**CITY OF AUSTIN**  
**Board of Adjustment/Sign Review Board**  
**Decision Sheet**

**CASE NUMBER:** C15-2014-0073

**ADDRESS:** 900 JEWELL ST

**VARIANCE REQUESTED:** The applicant has requested variances to Section 25-2-492 (D) (*Site Development Regulations*) to: decrease the minimum lot size from 5,750 square feet (required) to 3,707 square feet (existing); and decrease the minimum front setback from 25 feet (required) to 19 feet (existing); and decrease the side setback from 5 feet (required) to 4 feet 4 inches (existing); and decrease the street side setback from 15 (required) feet to 9 feet 9 inches (existing); and decrease the rear setback from 10 feet (required) to 0 feet (existing) in order to expand the footprint of an existing, non-complying residential structure with a 6 foot x 32.3 foot addition and retain shed located along the rear property line in an "SF-3-NP", Family Residence zoning district. (Bouldin)

# SURVEY PLAT OF

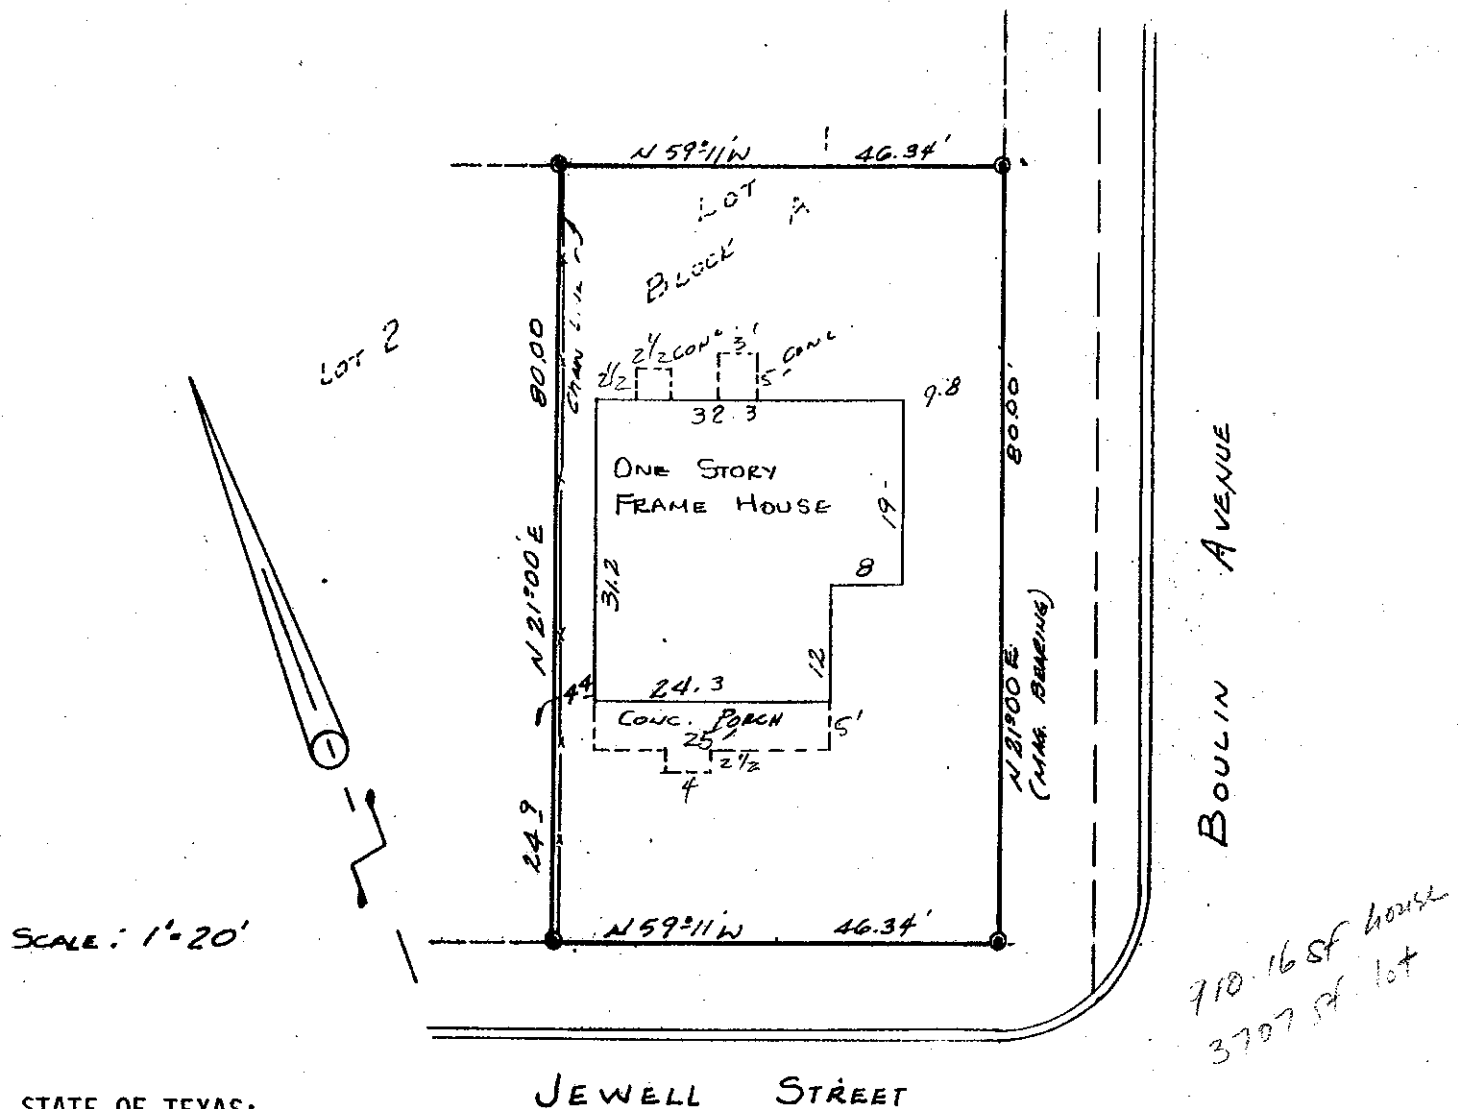
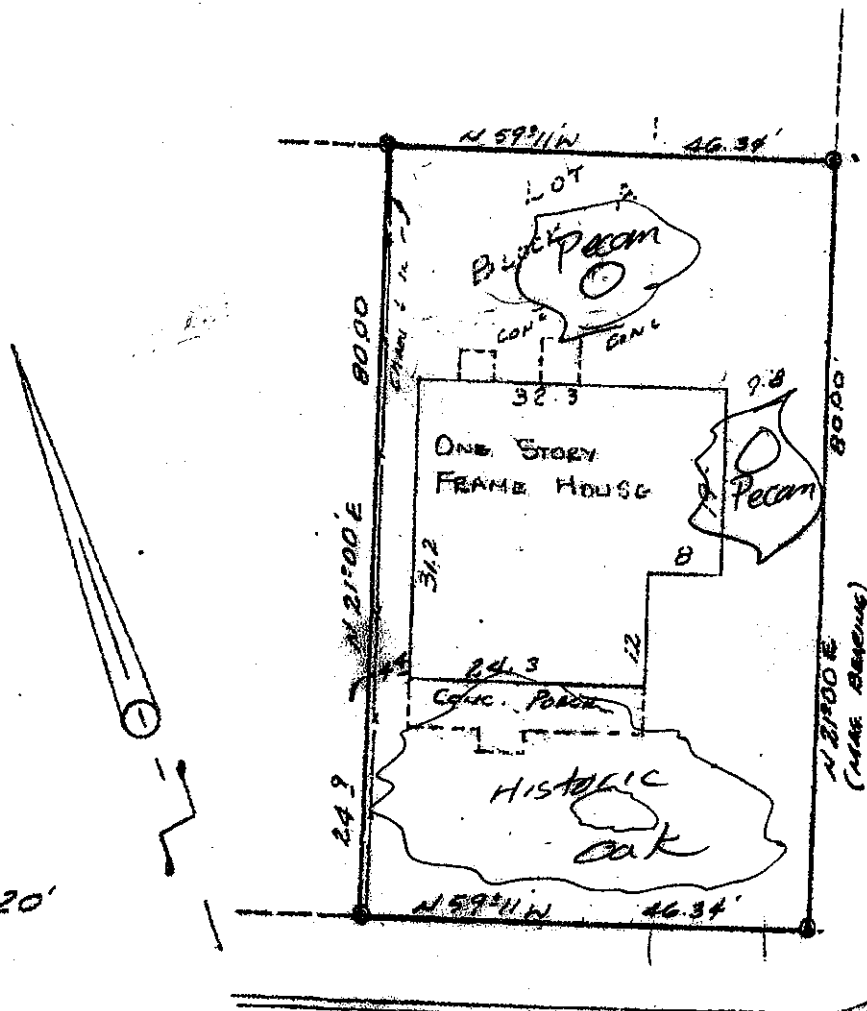
Regarding Rear yard setback; the existing shed is a setback violation and gross fire hazard. The site development standards are in place for good reason as fire code prohibits such structures which occupy an area directly adjacent to an existing primary dwelling (buildable property line) in addition to residential design & compatibility standards. I have attempted to broach this issue with the current owner to no avail. For reference, the illicit shed is one-foot off the rear property line (my side yard setback) and is 9'-6" tall and its eave extends to/beyond the boundary (please see attached photo). Additionally, the eave height is higher than the header height of my two windows directly opposite and the shed blocks all views/sunlight.

Regarding Street side yard setback; the existing structure was clearly within setback requirements and at some time in the past had an 8-foot addition which now encroaches the setback. This is evident in the dogleg of the sidewall and roof lines of the structure.

Regarding Interior side yard setback, we note the proposed site plan/sketch does not depict the water & gas utilities that run the entire length of the lot. This prescriptive easement has been serving both mine and the subject property since ~1952. Any future construction within the setback may conflict with existing water & gas utility lines.
